Chip To Module Twin Axial Cable Channels For 400 Gb/s: Re-examining the Insertion Loss Equation

Richard Mellitz, Samtec, April 24, 2017

Option A

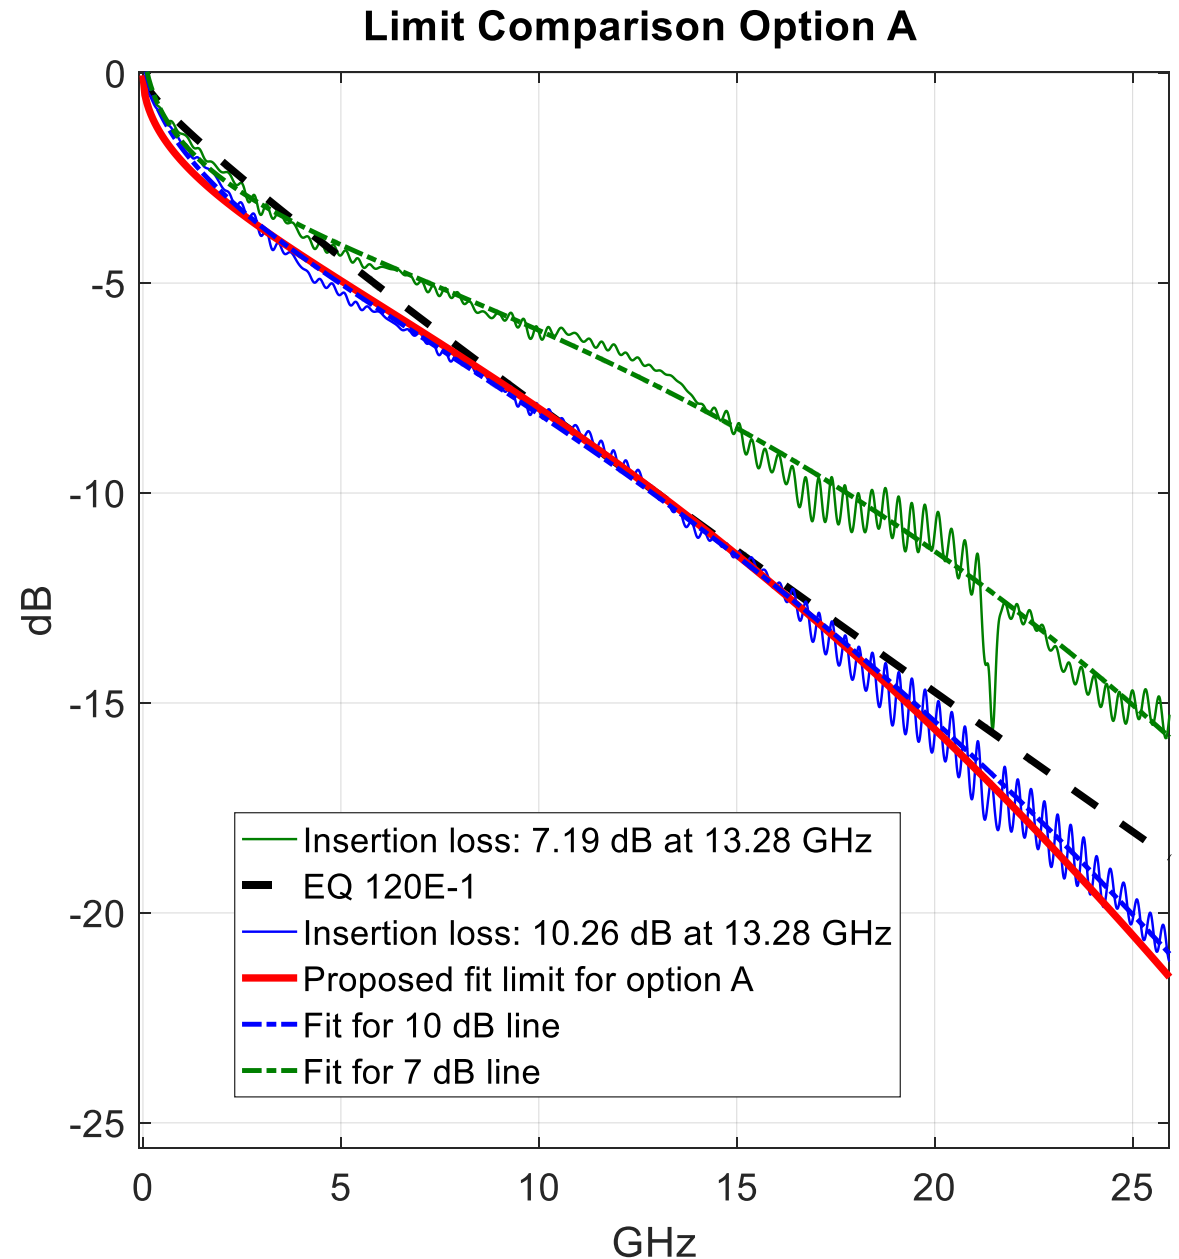
The Issue: Cable R² Loss Not Considered

- Change equation 120E-1 to form of 93A-51 and change text to

“The supported insertion loss fit budget is characterized by Equation (120E-1) and illustrated in Figure 120E-4.” The insertion loss fit is describe in 93A.3

$$IL_{fitted}(f) = a_0 + a_1\sqrt{f} + a_2f + a_4f^2 \quad (93A-51)$$

- [a0 a1 a2 a4] =
[0.05 1.65 0.155 0.0117]

Option B

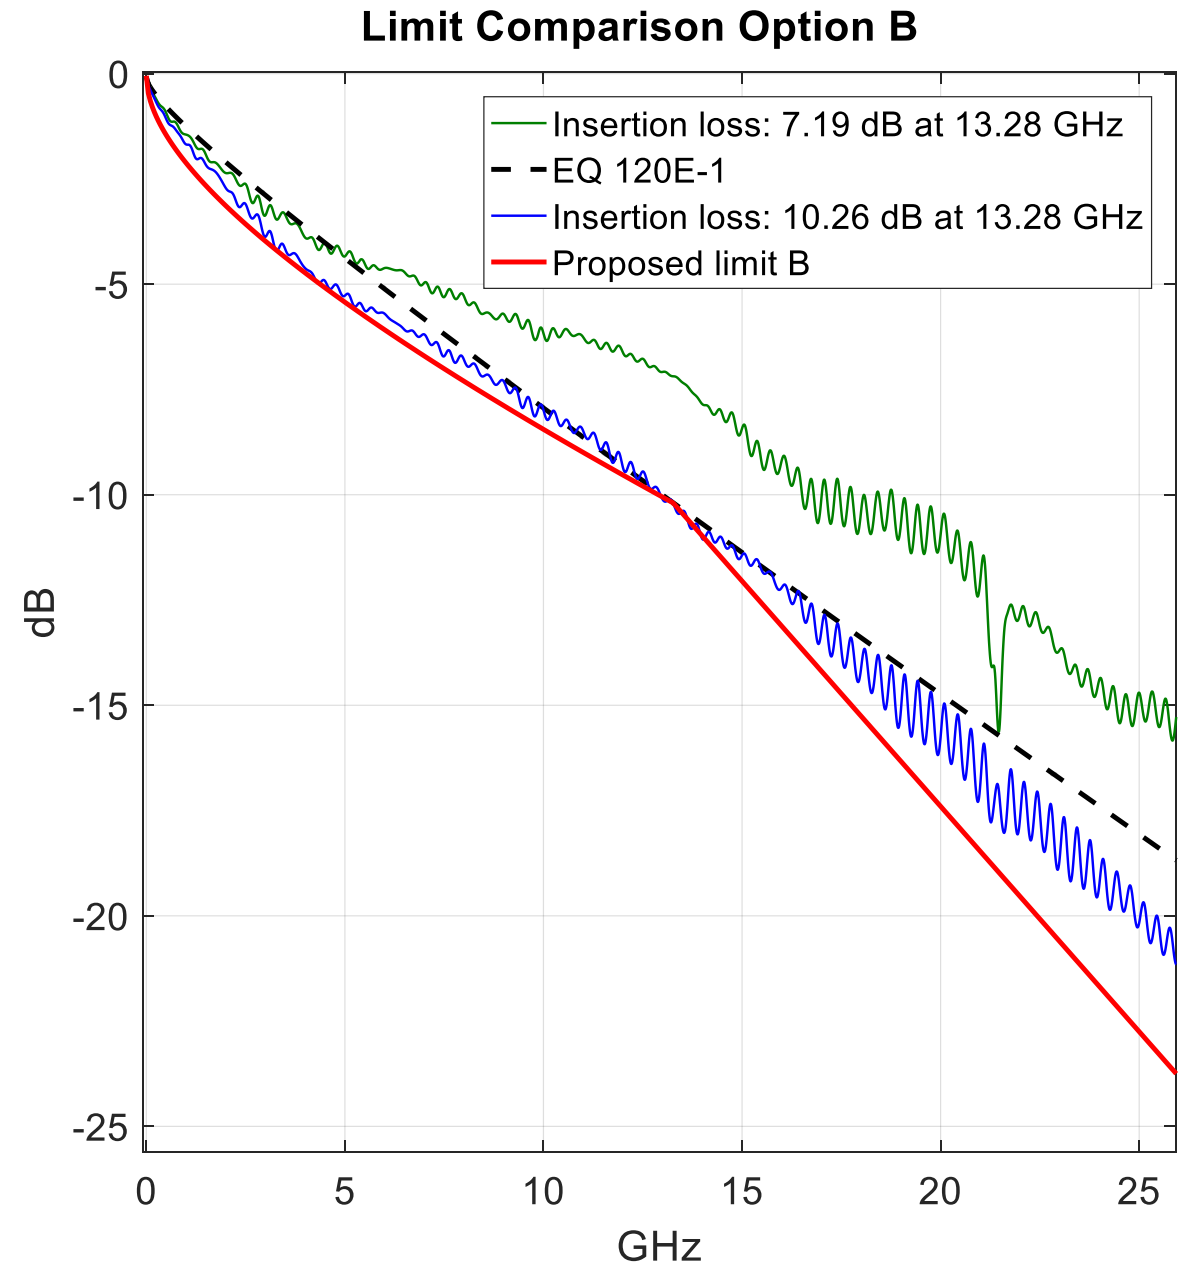
- ▶ Use a limit line which encompasses r^2 cable loss.

$$\begin{aligned} & \text{Insertion_loss}(f) \\ &= \begin{cases} 0.05 + 1.8\sqrt{f} + 0.2705f \text{ (dB)} & f \leq 13.28 \\ -4.0096 + 1.07f \text{ (dB)} & f > 13.28 \end{cases} \end{aligned}$$
